Technical Service Bulletin: tsb100049	Released Date: 18-Jun-2010
Front and Rear Crankshaft Seal Leaks

Front and Rear Crankshaft Seal Leaks

Location of Part Number and Batch Number on the Seal

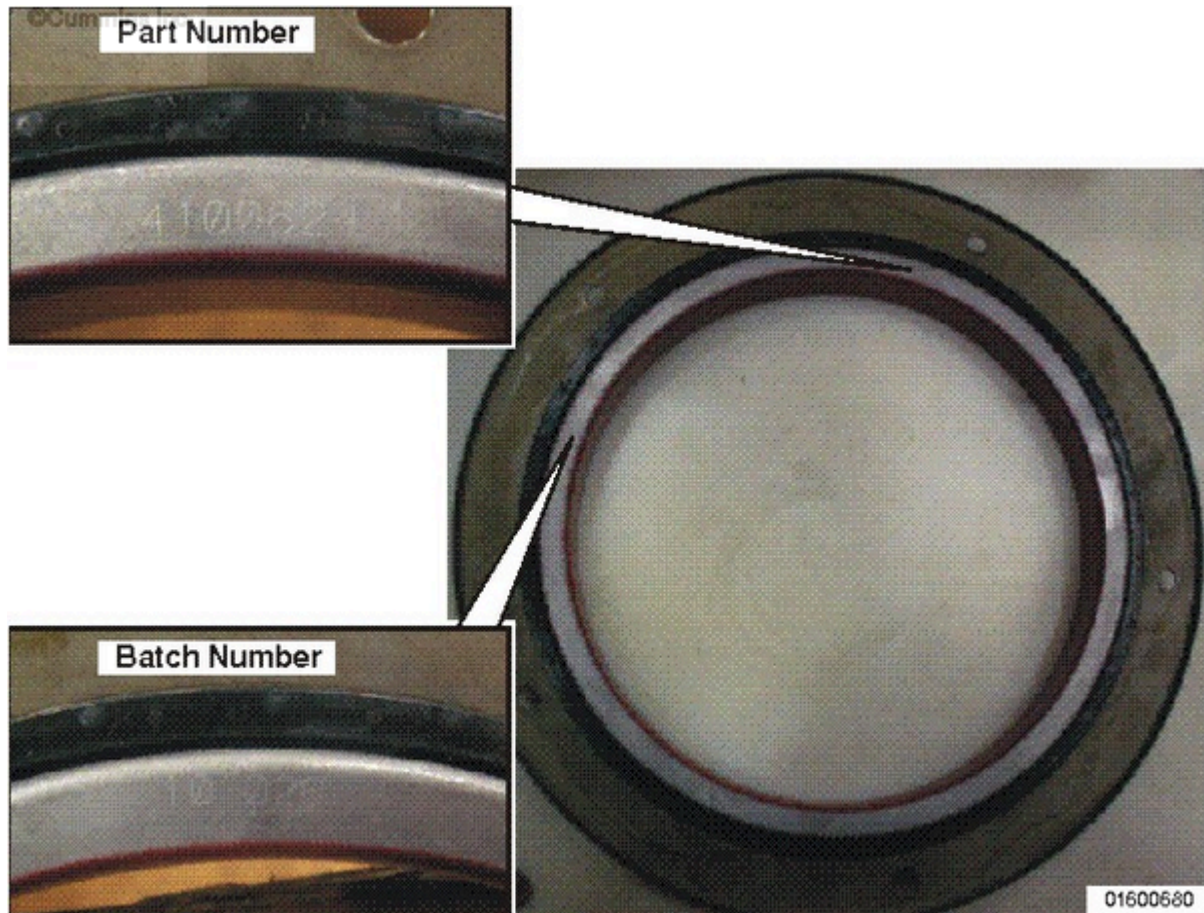
Crankshaft seals that match the part number and the batch numbers shown below should be removed from stock and **not** used on any engine.

Front crankshaft Seal Batch Numbers (Part Number: 4100624)

- 09-131
- 09-280
- 09-323

Rear crankshaft Seal Batch Numbers (Part Number: 4100625)

- 09-196
- 09-133

All stock of crankshaft seals **must** be checked against the batch numbers listed. If any seals match the batch numbers they **must** be removed from stock and **not** used.

Return the seals that match the batch numbers to PDC where they were purchased, referencing the Parts Alert Number 012-10.
